Re: Affected Property Assessment Report, Former Operating Plant, Frisco Recycling Center,
Frisco, Collin County, Texas (Agreed Order Docket No. 2011-1712-IHW-E);
City of Frisco comments

This submittal is the City of Frisco's (the City's) comments on the Affected Property Assessment Report (APAR) submitted by Exide Technologies (Exide) for the former Exide battery recycling facility in Frisco, Texas. This area is also known as the Bowtie Parcel in the context of the Exide – City of Frisco Settlement Agreement that required closure of the Exide facility. The adjacent J Parcel is being purchased by the City for future development following remediation by Exide under a Texas Commission on Environmental Quality (TCEQ) Voluntary Cleanup Program (VCP) application.

COMMENTS ON APPENDIX 7 OF AFFECTED PROPERTY ASSESSMENT REPORT,
FORMER OPERATING PLANT, FRISCO RECYCLING CENTER, FRISCO, COLLIN COUNTY,
TEXAS (AGREED ORDER DOCKET NO. 2011-1712-IHW-E), PASTOR, BEHLING &
WHEELER LLC, DATED 7/10/2013

C'
EAST

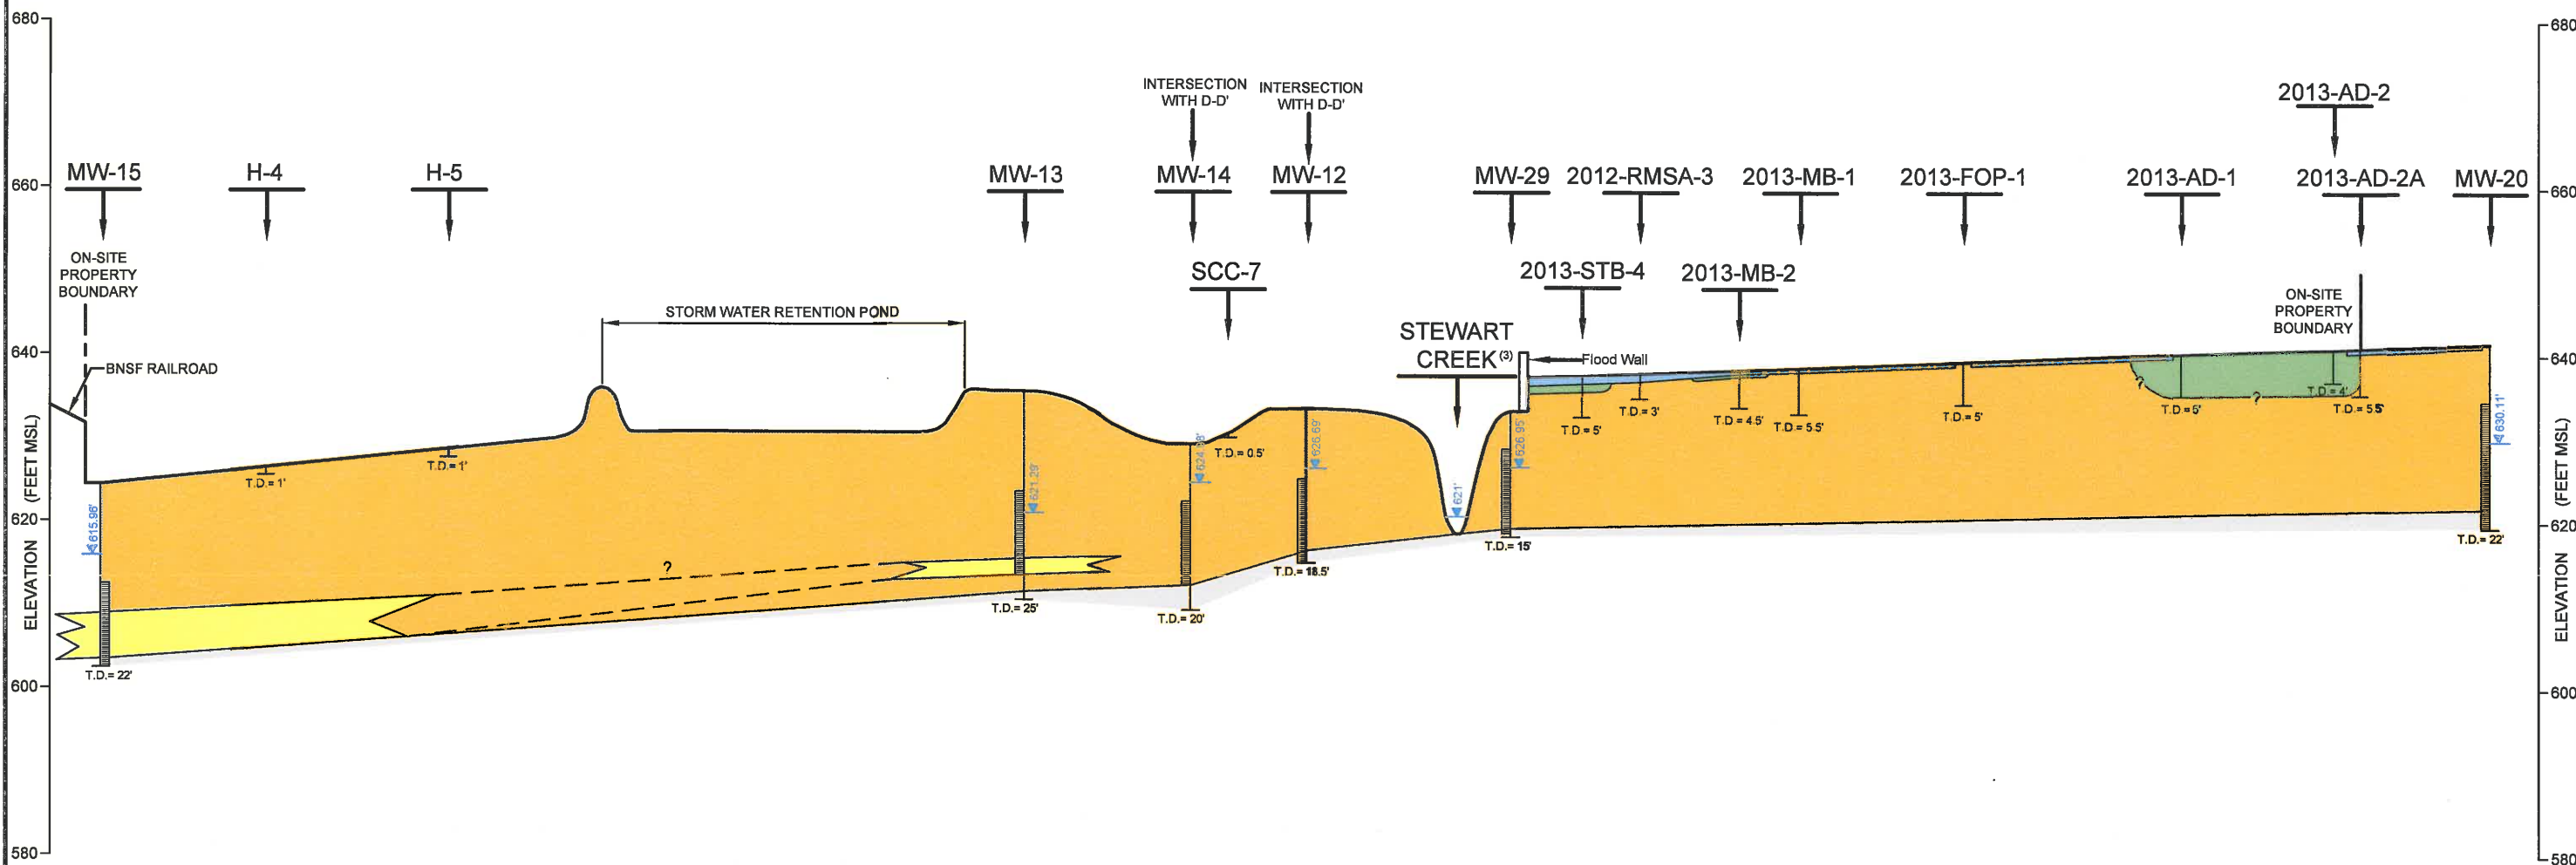
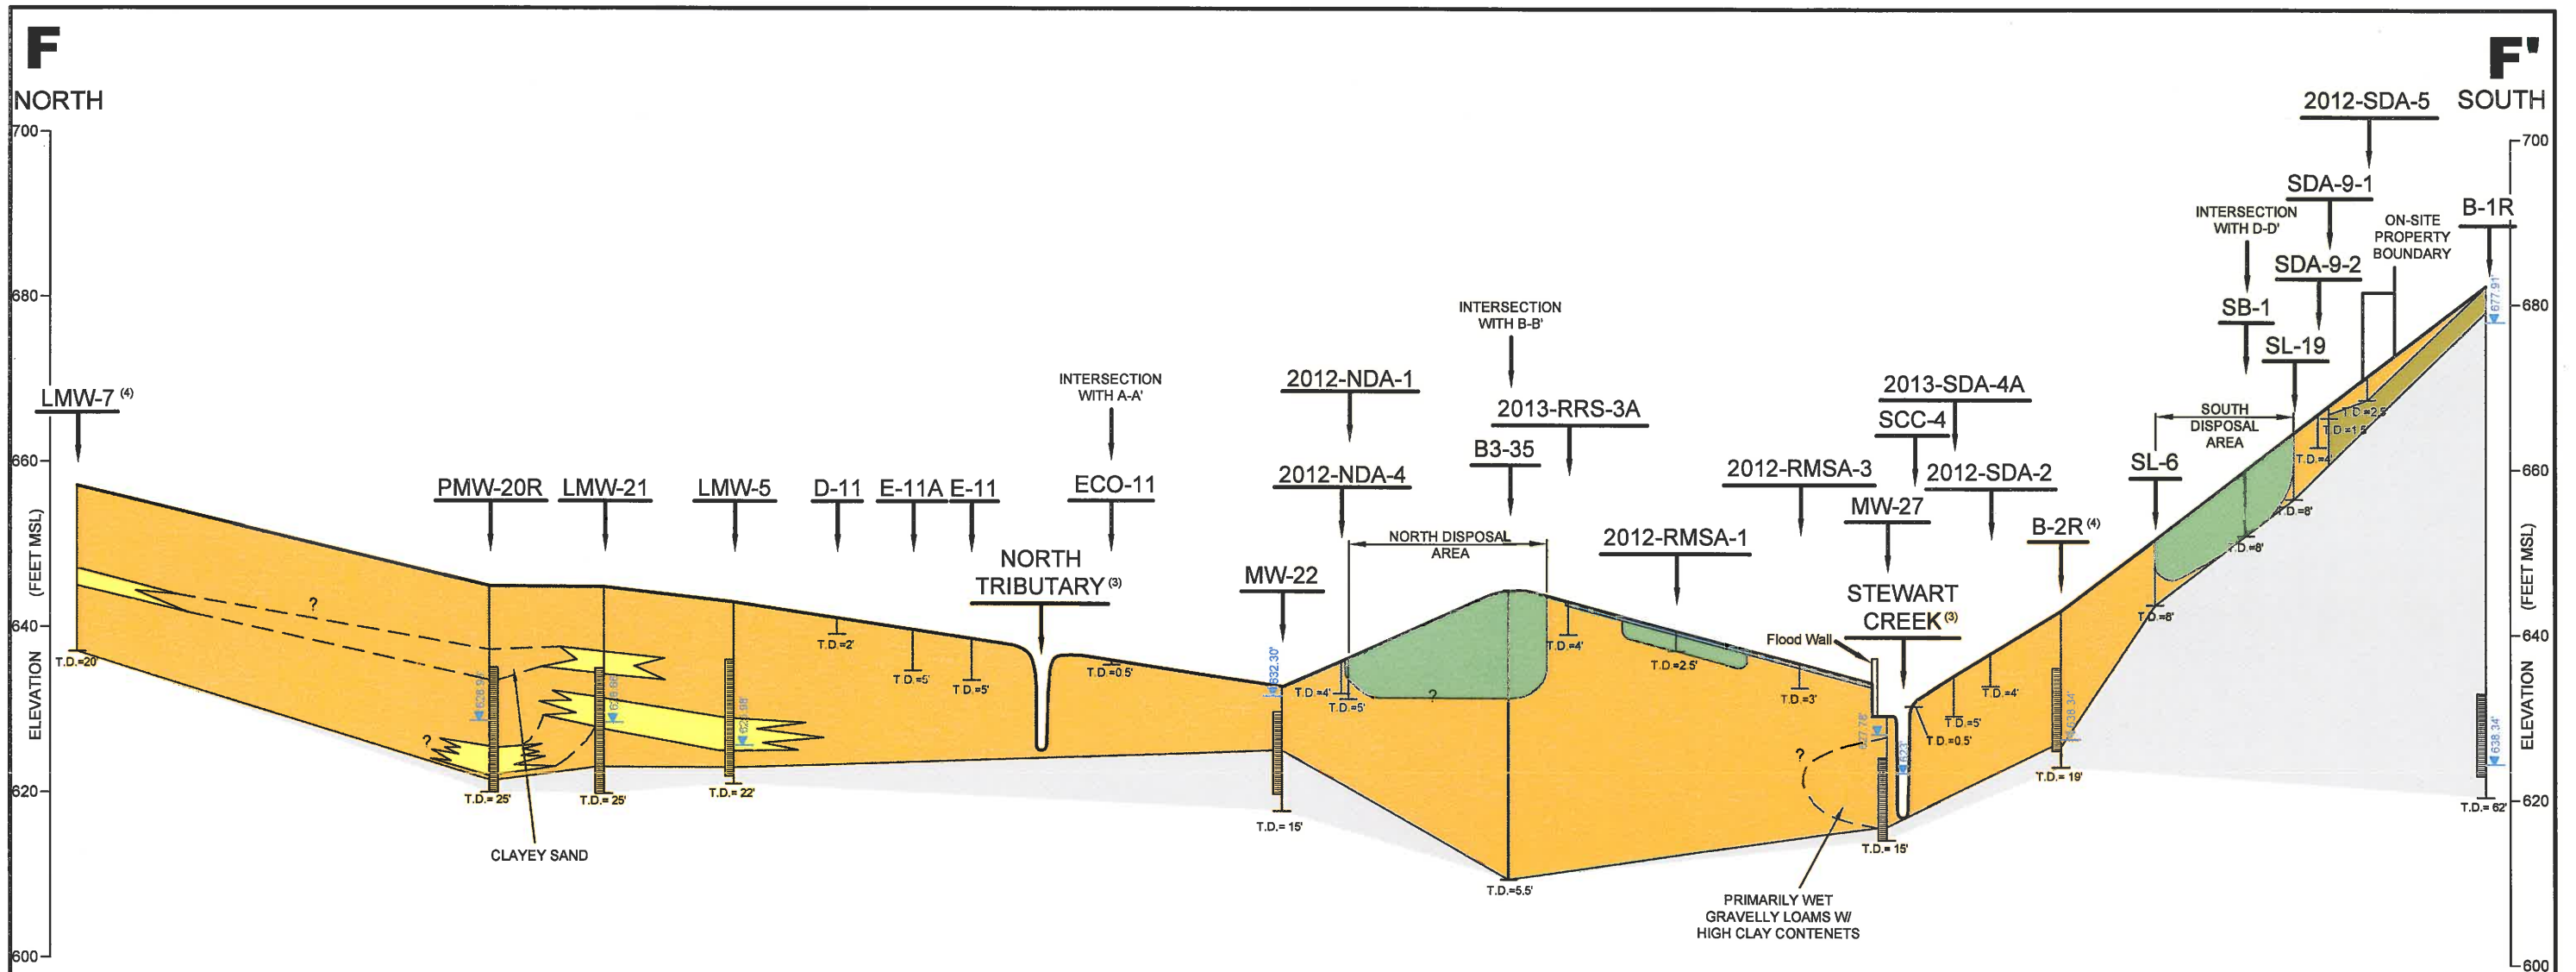
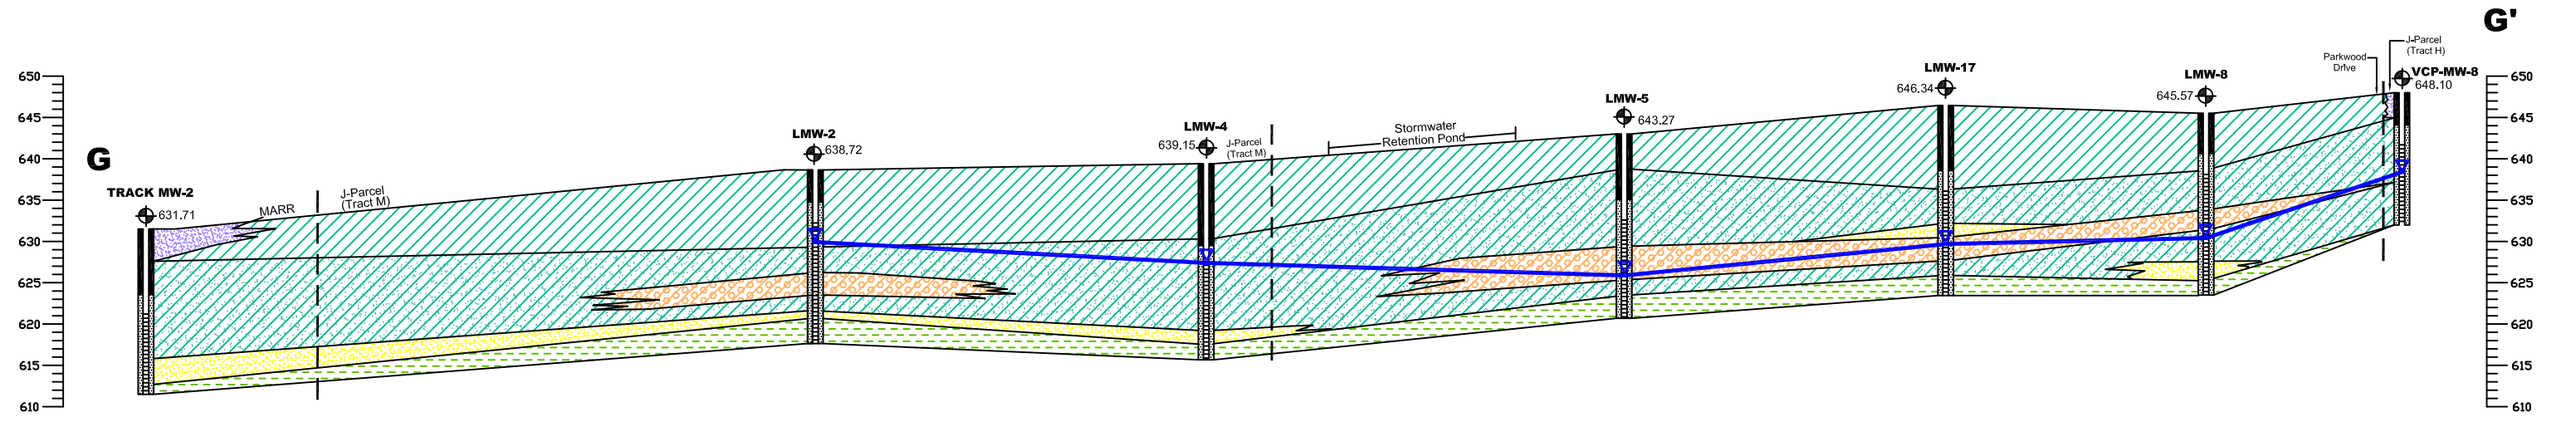
A key part of the Exide groundwater classification argument is that the hydrogeology of the groundwater bearing unit (GWBU) consists of disconnected areas of highly permeable sand and gravel. See Section 6.2.2 of Appendix 7 Updated Groundwater Resource Classification Evaluation. The City notes that Exide provides very convoluted cross sections in the APAR to support this argument. These cross sections defy common sense and normally accepted professional practice. Prior to submission of the APAR, the City provided Exide with accurate cross sections which demonstrate the continuous nature of the subsurface hydrogeology. Exide chose not to include these accurate cross sections in the APAR since they undercut the basic technical assumption for Exide's convoluted regulatory argument for a Class 3 groundwater designation. Those cross sections are included in Attachment C.

The cross sections that were included with the Groundwater Memo (Sections A-A’ through F-F’) have been revised to illustrate the interpretation of the City’s consultants that connectivity exists between transmissive strata at the site and are attached to this document.

Figure 9. Unconfined Conditions

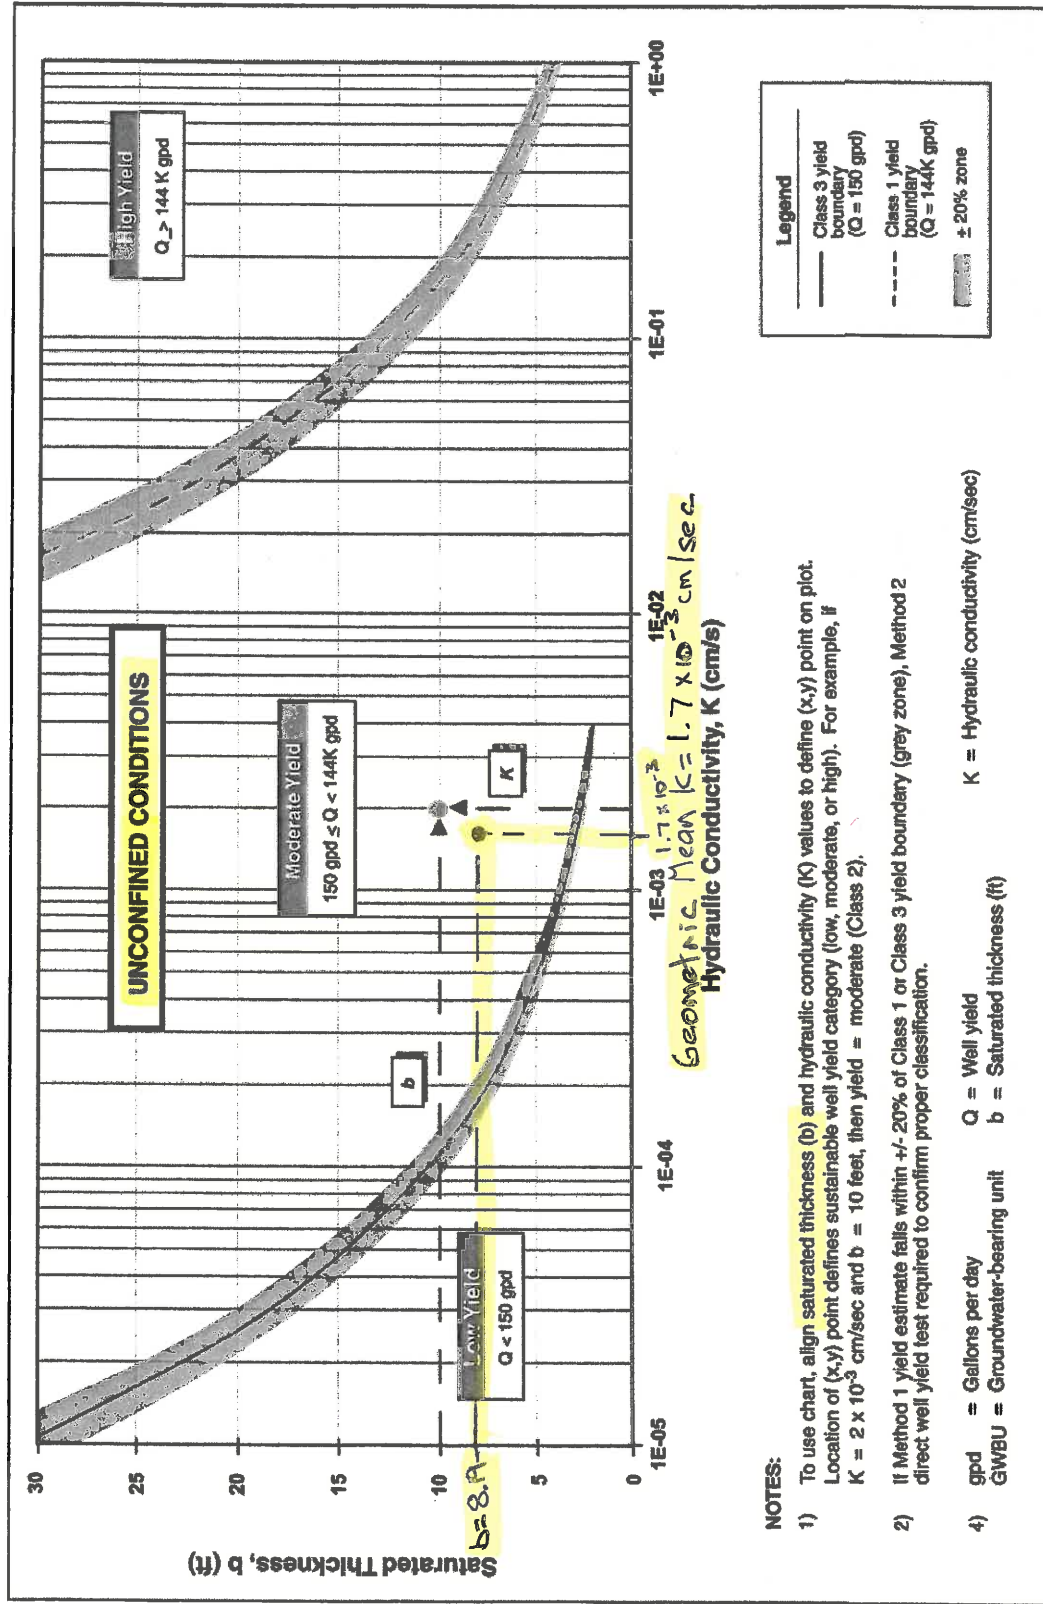
"It is instructive to review Figure 9 from TRRP-8 (included as Attachment F of this appendix) when evaluating the groundwater yield of the clayey gravels. Figure 9 graphically illustrates the relationship between saturated thickness (b), hydraulic conductivity (K) values, and well yields (Q). According to TRPP [sic] Section 2.7.1 (Method 1), direct measurement of well yield is not required unless the calculated yield of the groundwater-bearing unit is within 20 percent of the Class 2/3 boundary (the area shaded gray on Figure 9). At the Site, the average thickness of the clayey gravels is about 2 feet, with an average K value of 1.7×10^{-3} cm/sec. When these values are plotted on Figure 9 (Attachment F), the chart shows that the clayey gravel is "Low Yield" only capable of yielding about 80 gpd [gallons per day], well below the Class 2/3 boundary; thus according to Note 2 on Figure 9, direct well yield tests are not required to confirm proper groundwater classification."

The City agrees that it is instructive to review Figure 9 from TRRP-8. However, in doing so it appears that PBW has performed that comparison incorrectly. In their evaluation, PBW used the average thickness of the "clayey gravels", which would be correct if those "clayey gravels" were considered a confined unit. But the saturated stratum being tested is unconfined. Therefore, PBW should have used the saturated thickness of the groundwater bearing unit being tested, which is clearly spelled out in the instructions for Figure 9 and on page 17 of TRRP-8, which defines saturated thickness as, "For unconfined GWBUs [Groundwater Bearing Units], the saturated thickness (b) at each location is the vertical distance from the static water level elevation to the base of the saturated unit".

PBW also appears to have made a similar error when calculating well yields for wells in “clayey gravel” and “gravel and sand”. In both cases they used the thickness of the stratum they felt was producing the groundwater from those wells, versus the measured saturated thickness at those wells. What is unusual is that their error was not carried through with the yield tests performed on monitoring wells installed in clays (“saturated soils”), where yields were calculated using what appear to be the correct saturated thicknesses.

When completing Figure 9 from TRRP-8 using the hydraulic conductivity (k) value calculated by Exide for the Bowtie APAR and a saturated thickness of 8.19 instead of 2.0, the City has determined that Exide's conclusion that the projected yield of these wells falls within the Class 3 boundary is incorrect. Per Figure 9 those wells clearly represent a Class 2 resource and should be treated as such until or unless yield testing performed on them suggests otherwise. The Figure 9 interpretation completed by the City is provided as Attachment C to this document.
